Memo

Subject: **Tekapo B Power Station tailrace weir and chute – implementation of draft consent conditions**

The purpose of this memorandum is to provide advice to Meridian and the Expert Panel considering Meridian's fast-track application on the practicality of implementing draft consent conditions 20 and 22 in respect of the Tekapo B Power Station tailrace weir and chute as proposed by the Panel, together with suggested changes to those conditions advanced by Genesis Energy Limited and Canterbury Regional Council.

Figure 1: Predicted Lake Pūkaki storage levels for the period 2026-2028 under conditions of eased operation with draft consent

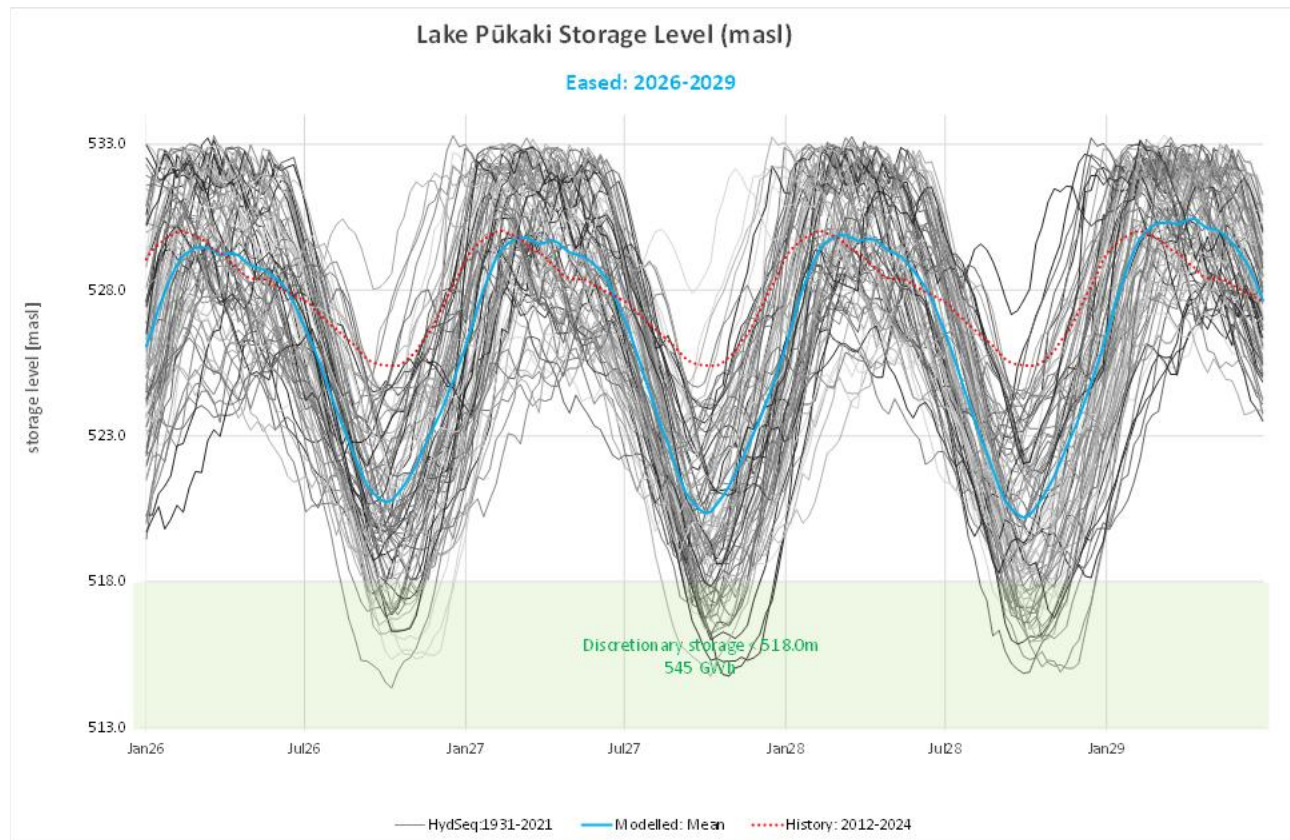
Figure 1 shows predicted Lake Pūkaki storage levels for the period 2026-2028 under the draft consent based on historic lake inflows and estimates of projected future power demand and likely future generation availability. Preceding dry conditions with low inflows would need to occur for the level of Lake Pūkaki to fall below RL 518 m. As seen in Figure 1, this would typically occur within the August to December period.

The practicality of being able to complete all the works required under Condition 20 is highly dependent on hydrological conditions continuing to be favourable throughout the installation period. Based on historic inflow patterns, there is a high likelihood that, even if the lake is drawn

down to a level suitable for all works to commence in the dry, a moderate inflow event will occur which will cause the lake level to rise again and prevent completion of the works.
